Project	<b>IEEE 802.16 Broadband Wireless Access Working Group</b> < <a href="http://ieee802.org/16">http://ieee802.org/16</a> >
Title	<b>Per-tone SINR Computation for MIMO STBC with MRC</b>
Date Submitted	<b>2009-01-05</b>
Source(s)	Rajni Agarwal Fujitsu Rajni.Agarwal@uk.fujitsu.com  *< <a href="http://standards.ieee.org/faqs/affiliationFAQ.html">http://standards.ieee.org/faqs/affiliationFAQ.html</a> >
Re:	TGmEVAL Change Request for 16m EMD (C802.16m-08/004r4).
Abstract	In this document, the expressions for MIMO 2x2 MRC receiver of the Per Tone SINR Computation section of the 16m EMD have been reviewed with the view to identify and explain error in the current expressions.
Purpose	For consideration and adoption into the 16m EMD document (C802.16m-08/004r4).
Notice	<i>This document does not represent the agreed views of the IEEE 802.16 Working Group or any of its subgroups.</i> It represents only the views of the participants listed in the "Source(s)" field above. It is offered as a basis for discussion. It is not binding on the contributor(s), who reserve(s) the right to add, amend or withdraw material contained herein.

# Per-tone Post Processing SINR for MIMO STBC with MRC

Figure 1 MIMO 2x2 STBC system with interferer 'j'

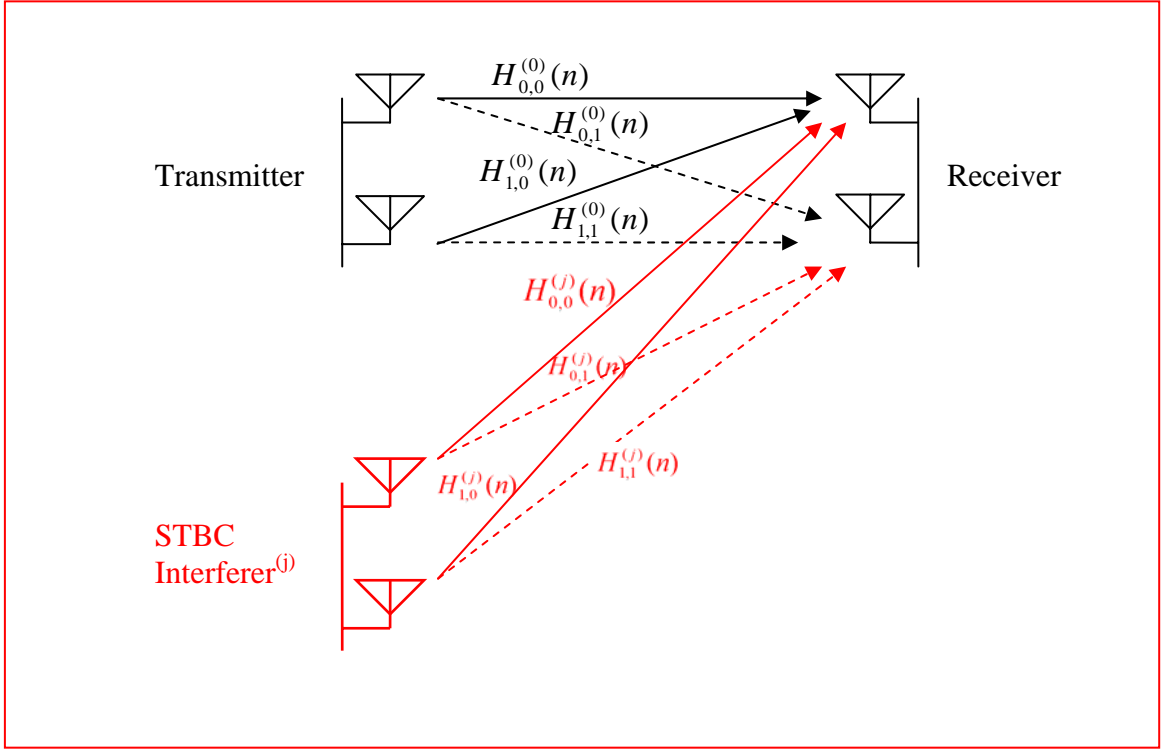
The Per-tone Post Processing SINR expression for MIMO STBC with MRC as described in section 4.4.3 of 16m EMD requires correction for the term ' $P_s$ ' in equation 73. The following provides an explanation with a brief derivation:

[Modify equation 73 of section 4.4.3 of the 16m EMD document by replacing the expression for 'P<sub>S</sub>' by that shown in the blue box:]

$$P_S = P_{tx}^{(0)} P_{loss}^{(0)} \sigma_0^2 \left( \sum_{t=0}^1 \sum_{r=0}^{N_R-1} |H_{t,r}^{(0)}(n)|^2 \right)^2,$$
